SOUTH SAN FRANCISCO FERRY TERMINAL PIER STRUCTURES

ADDENDUM NO. 2

December 9, 2009

Pre-Proposal Meeting attendees and notes
Q&As
Modification to Pier Doors
Modification of Liquidated Damages Paragraph
Changes the date and time that technical proposals are due
Remove redundant specification section on coatings
Remove specification section on the steel gangway

DATE
11/10/2009
SHEET
54 OF 120
DRAWING NO.
P-25
JOB NO.
1348

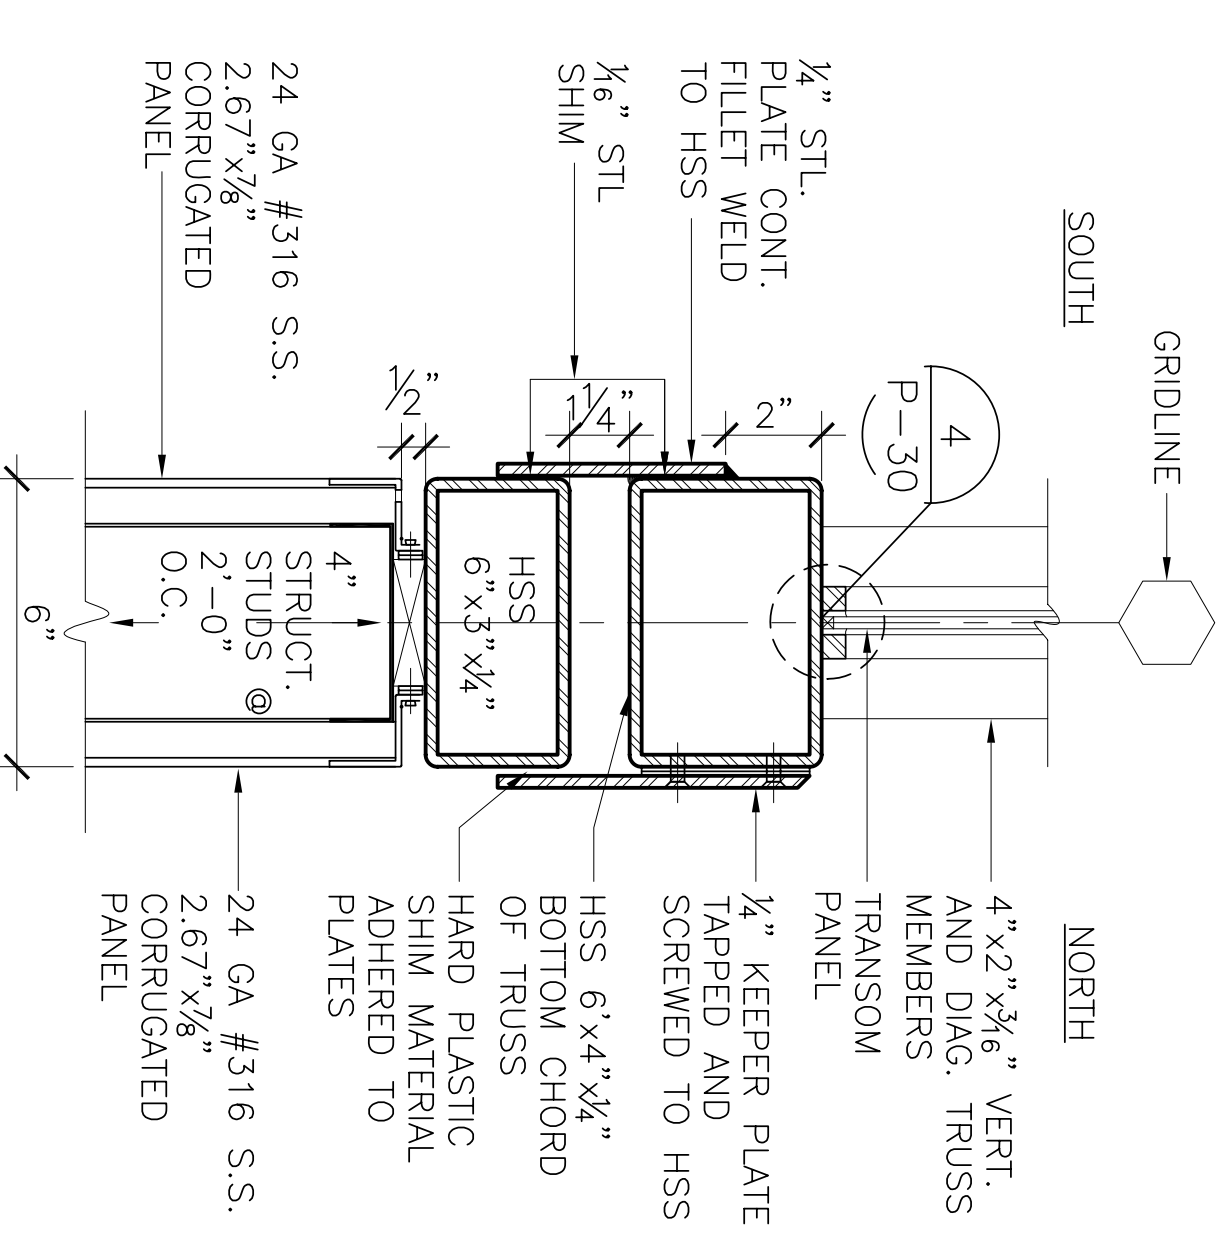
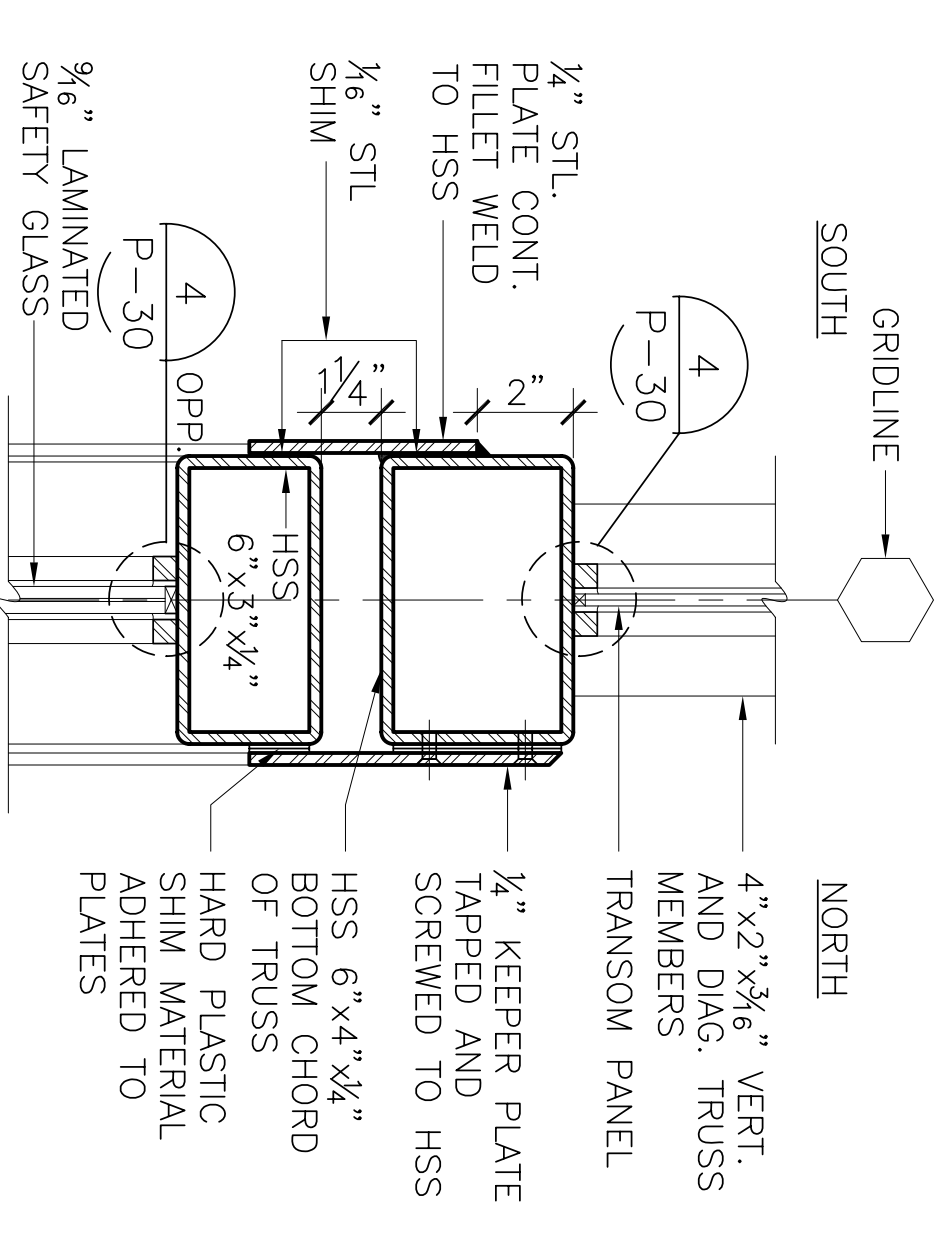
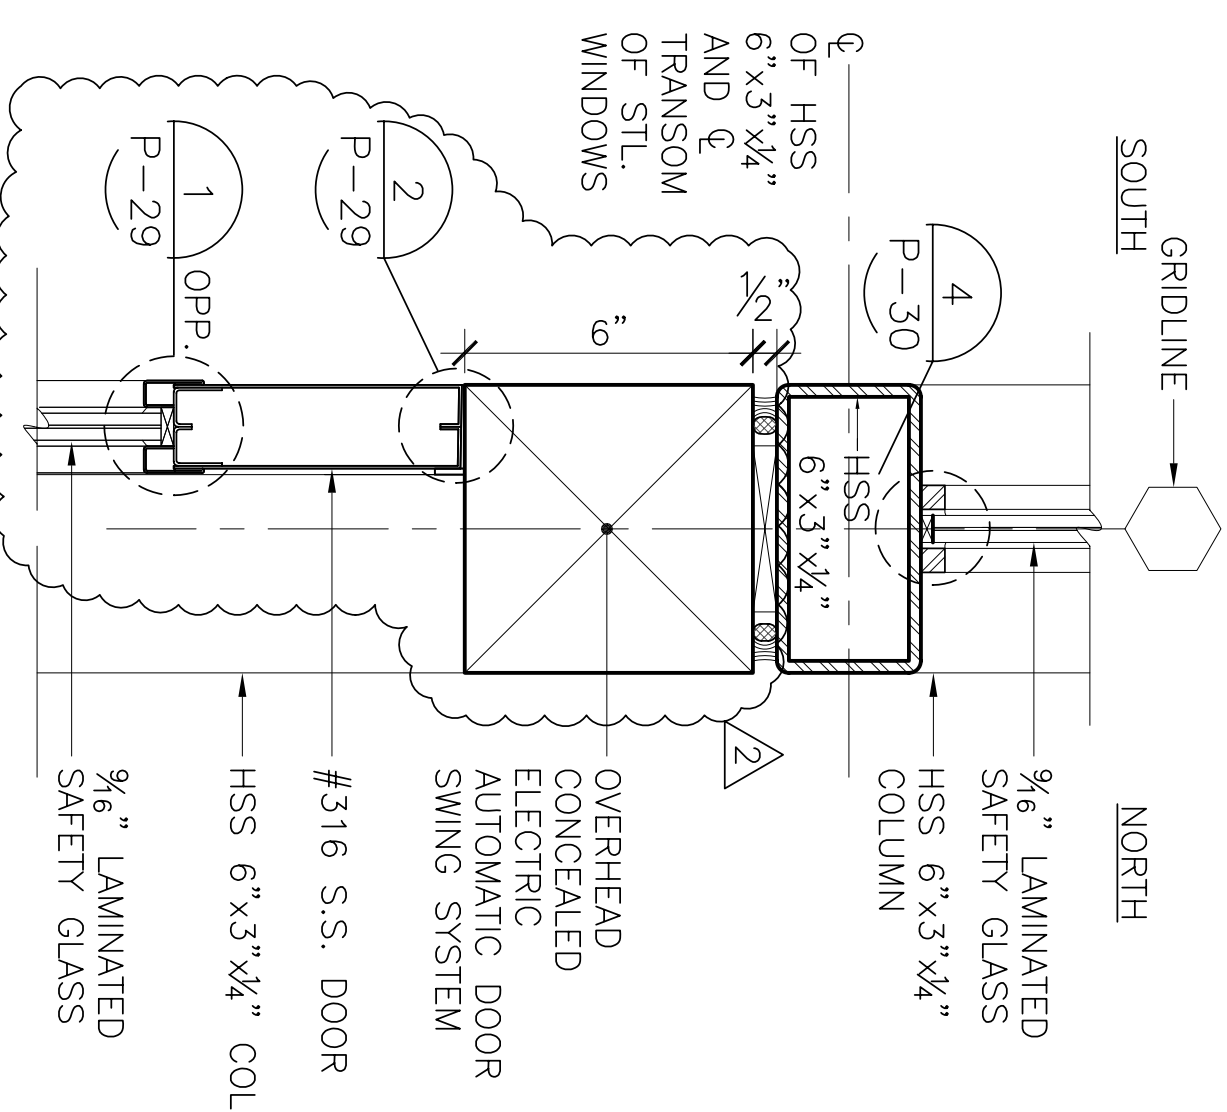
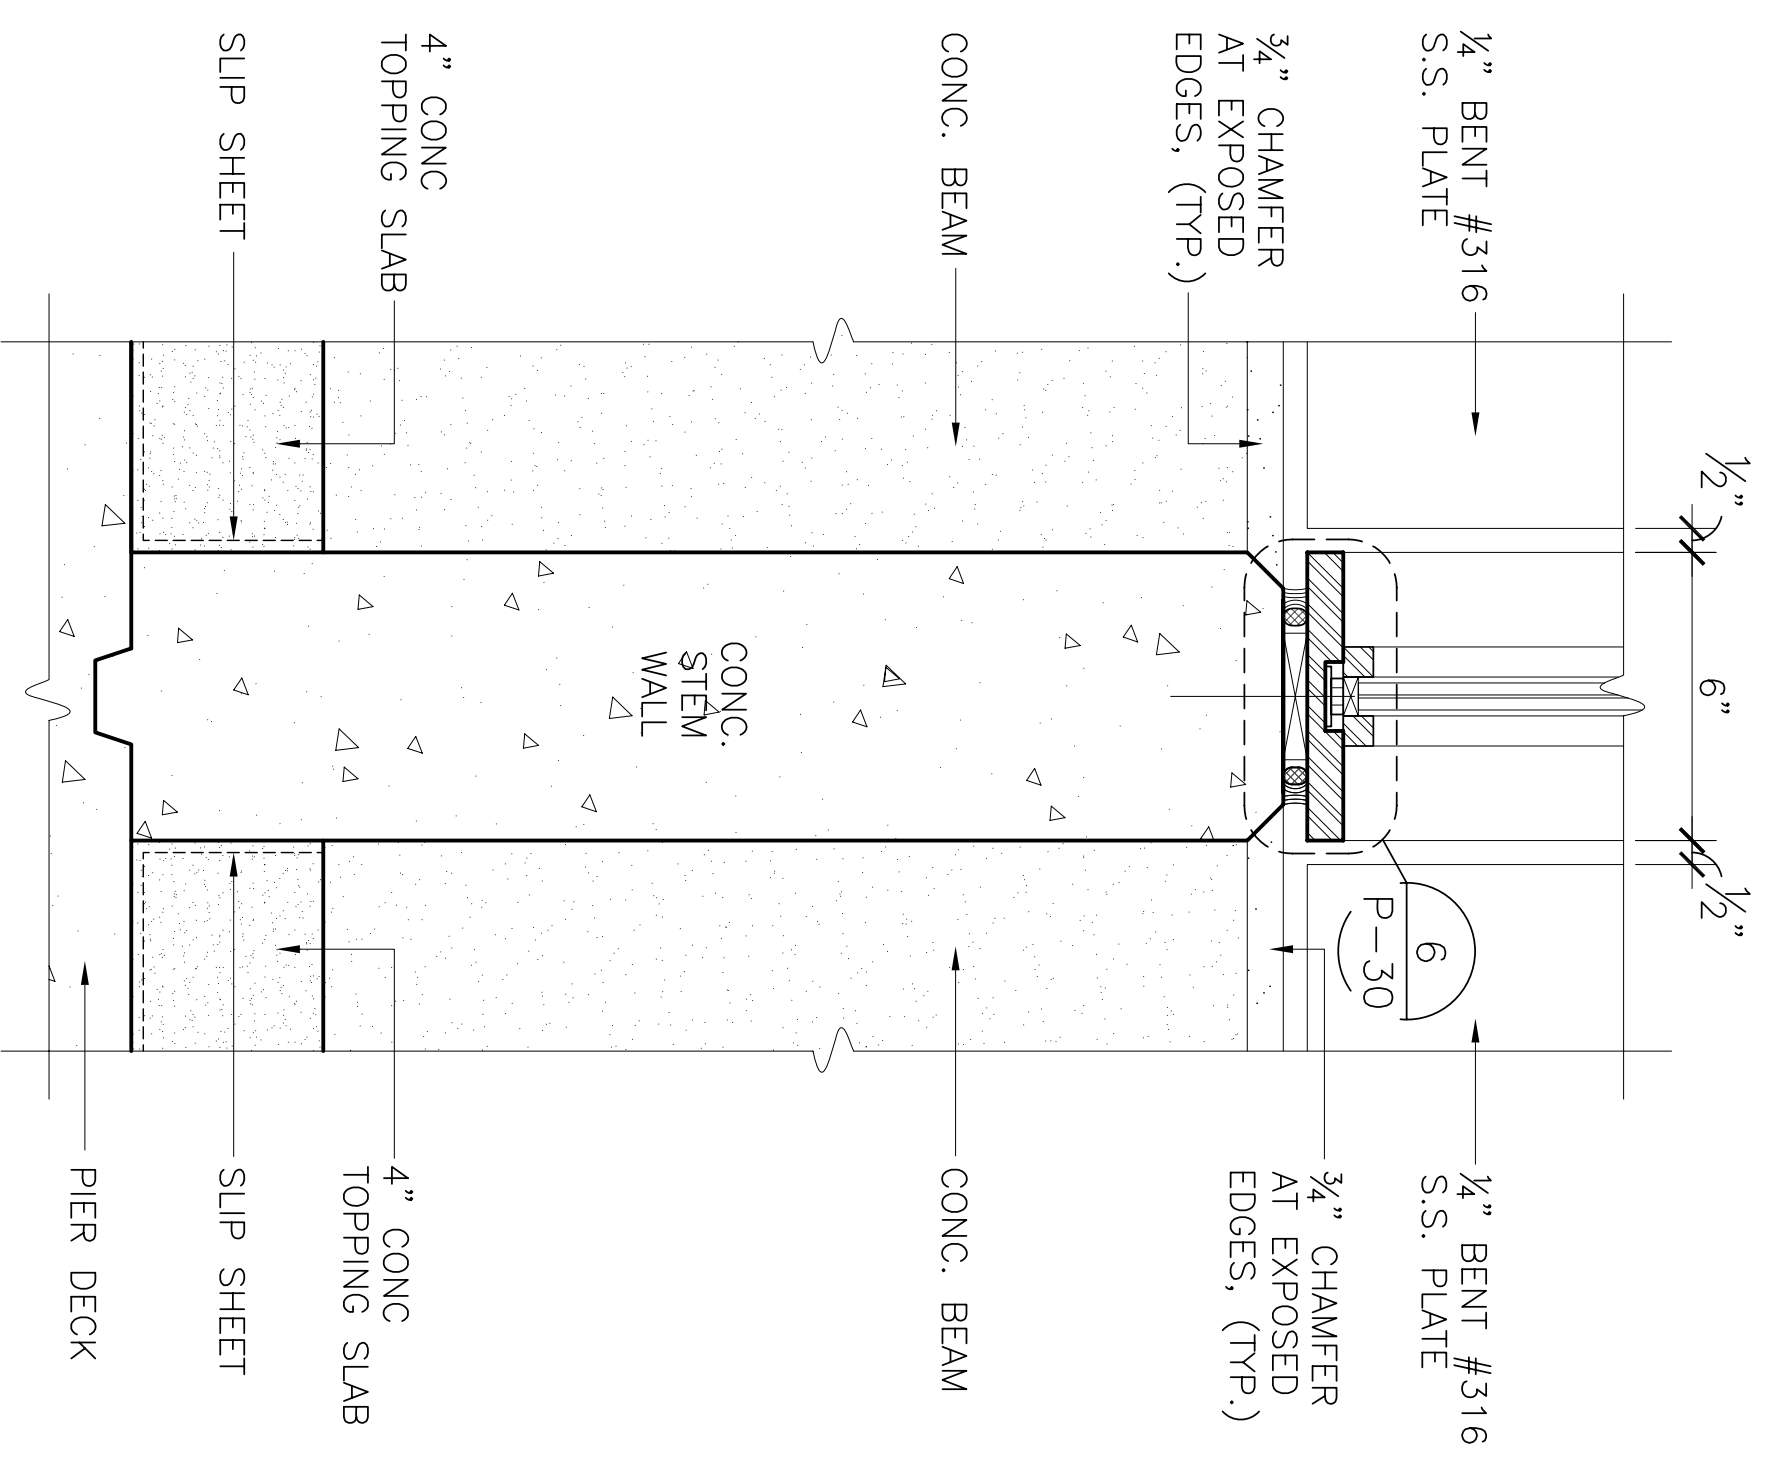
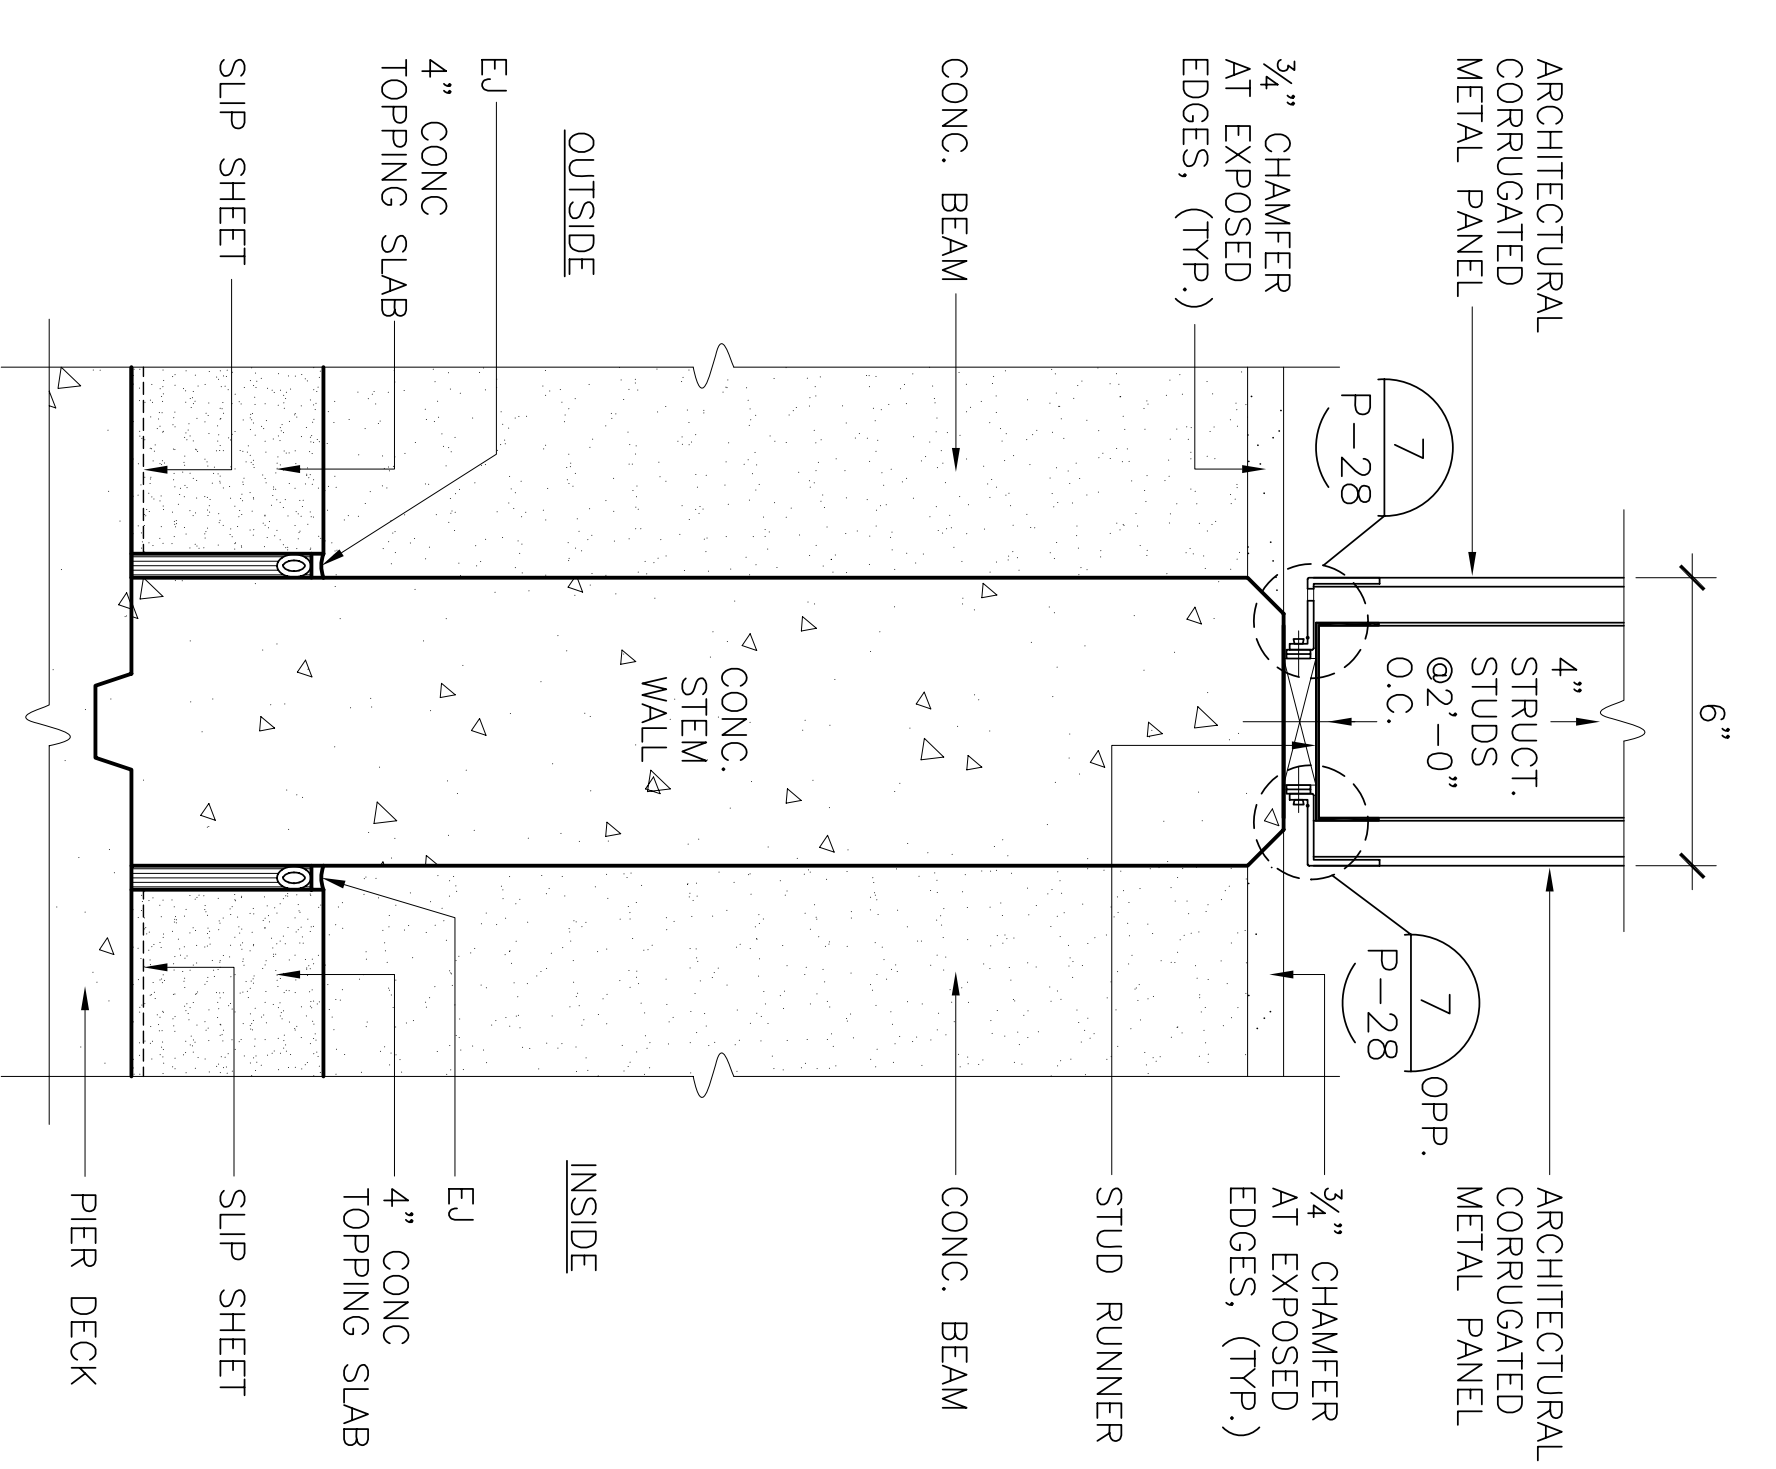
- A81: Yes, it is acceptable
- Q82: Package 2, drawing P-25, Details 1, 4, 5, and 8: The doors are currently drawing with no immediate vertical framing, using instead the steel vertical posts. It is recommended that a door frame from the manufacturer be introduced in order to facilitate typical fabrications such as door hinges, electrical wiring, and to address any clearance issues against the structural steel framing. This can be made from the same stainless steel material as the door leafs. Will this be acceptable?

- A82: Yes, the approach of using a stainless steel door frame would be acceptable subject to review of the specific proposed details.
- Q83: Package 2, drawing P-21, Detail A and 3: There is a 1/8" bent plate flashing shown on the 8" x 4" HSS beam. Is there a preferred attachment method by the owner (welded, mechanically fastened)?
